CITY OF NAPOLEON - BUILDING DEPARTMENT

RESIDENTIAL PLAN CORRECTION SHEET

ADDENDUM TO Permit No. 01568
Owner HAROLD BLUR
Contractor VERNON WATKIN
Location 707 S. PERRY

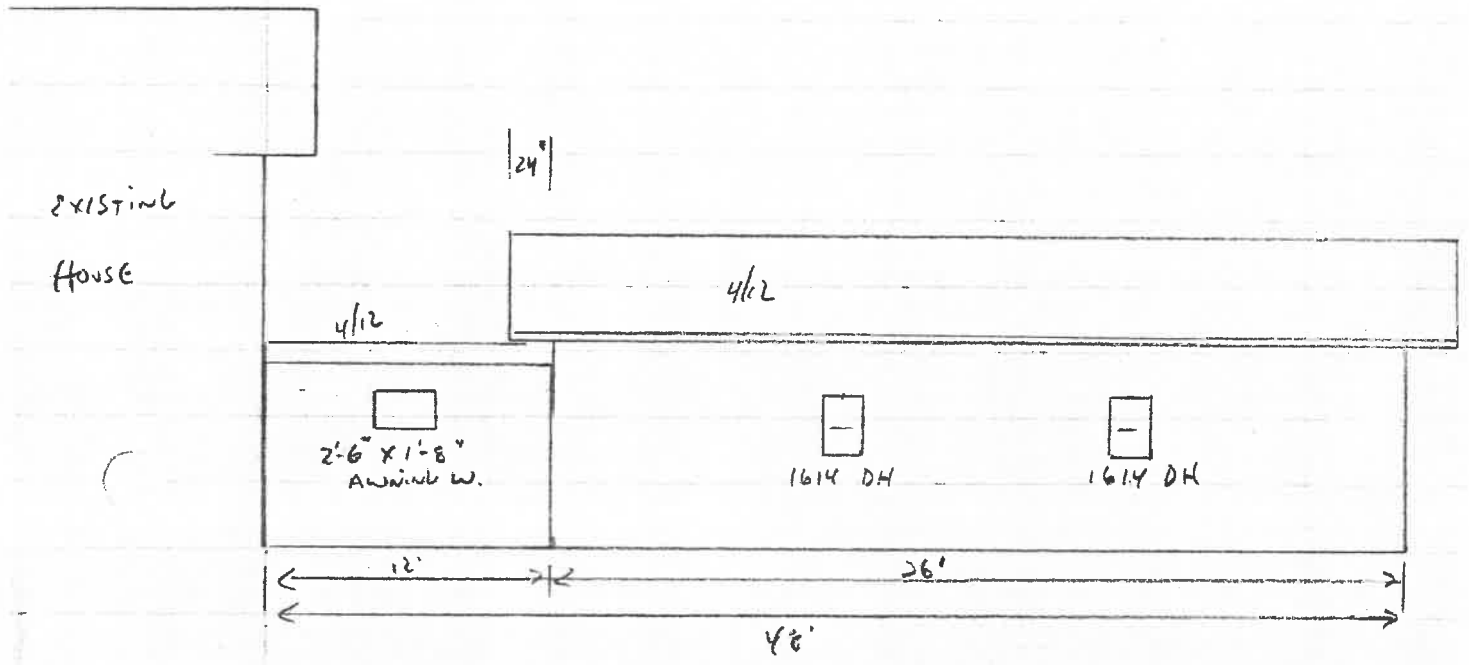
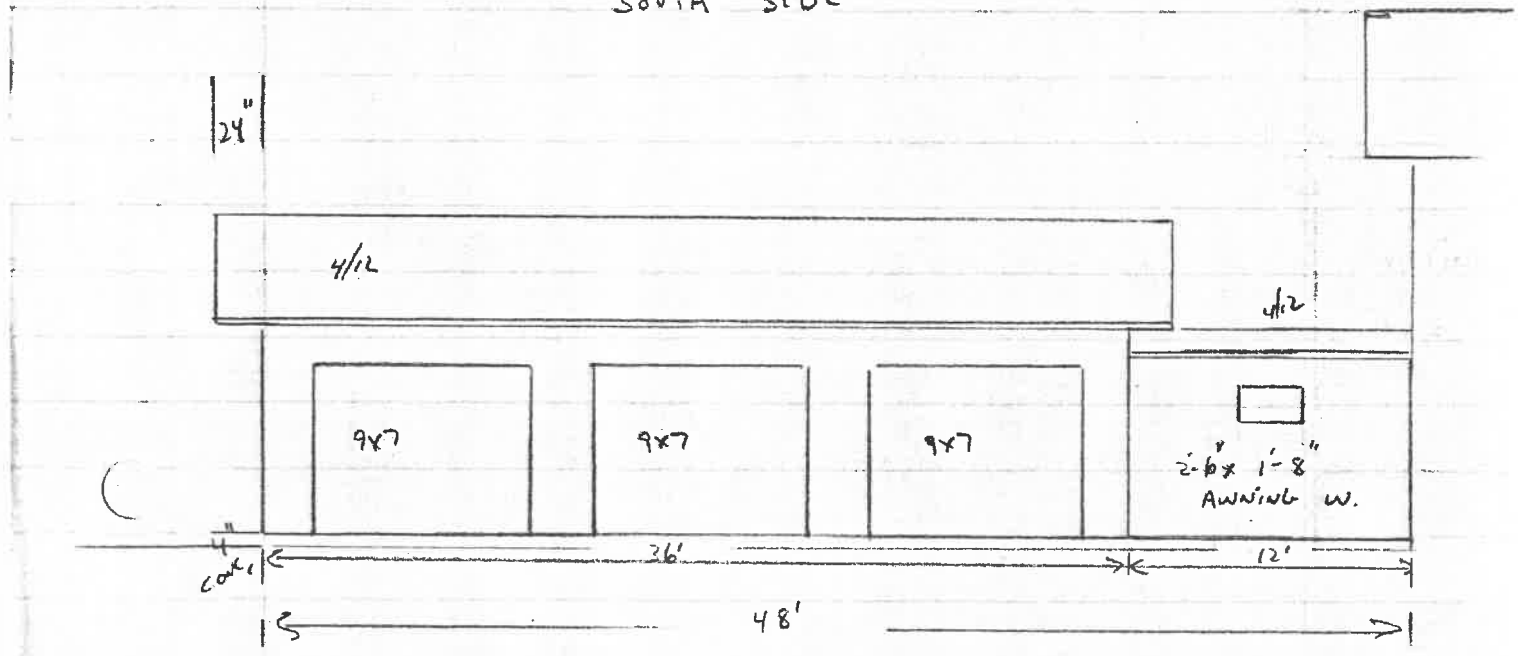
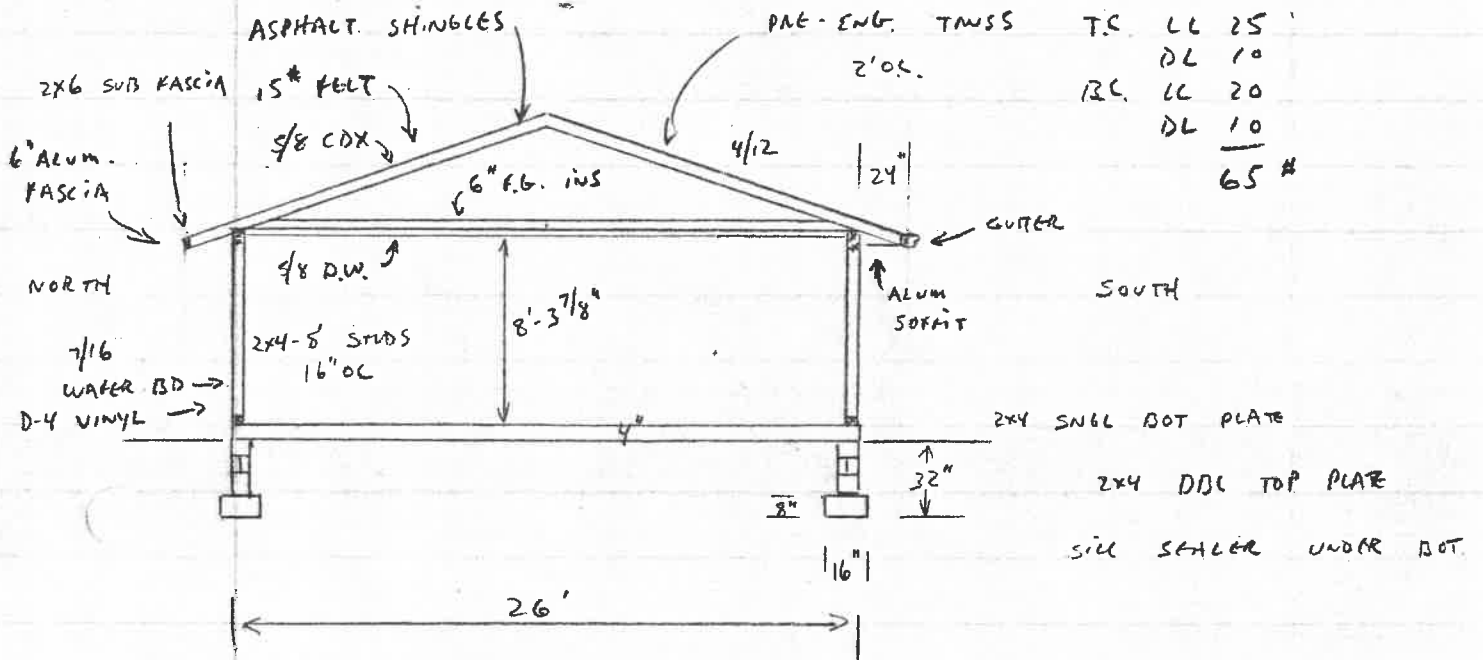
GENERAL			
<input checked="" type="checkbox"/>	Provide approved smoke detector(s) as req'd.		Show size of members supporting porch roof.
	Provide 1/2" gypsum wallboard between dwelling and garage, on garage side.		Provide double top plate for all bearing partitions and exterior walls.
	Provide min. 1 3/8" solid wood door from garage to dwelling. (or equal)		Provide design data for prefab wood truss.
	Submit fully dimensioned plot plan.		Ceiling joists undersized in _____
	Provide min. of 1-3'0" x 6'8" exit door.		Roof rafters undersized in _____
	Provide min. 22" x 30" attic access opening.		PLUMBING AND MECHANICAL
	Provide min. 18" x 24" crawl space access opening.		Terminate all exhaust systems to outside air.
	Provide approved sheathing or flashing behind masonry veneer.		Insulate ducts in unheated areas.
	Provide min. 15# underlayment on roof.		Provide backflow prevention device on all hose bibs.

Min. size of footer _____" x _____"		Maximum number of receptacles permitted on a G. F. C. I. circuit shall be 10 for 20 A. circuits and 7 for 15A. circuits.
<input checked="" type="checkbox"/>	Provide anchor bolts, 1/2" @ 6' o.c. 1' from each corner. Embedded 7" in concrete and 15" in masonry.		Refrigerators, microwaves, washers, disposal, furnace and air conditioners shall be on separate circuits.
	Show size of basement columns.		INSPECTIONS
	FRAMING		The following indicated inspections are required. The owner or his agent shall contact the City Building Dept. at least 24 hrs prior to the time the inspection is to be made.
	Show size of wood girder in _____.		<input checked="" type="checkbox"/> Footers and Setbacks.
	Provide design data for structural member in _____.		<input checked="" type="checkbox"/> Foundation.
	Floor joists undersized in _____.		Plumbing rough-in.
	Provide double joists under parallel bearing partitions.		Plumbing final.
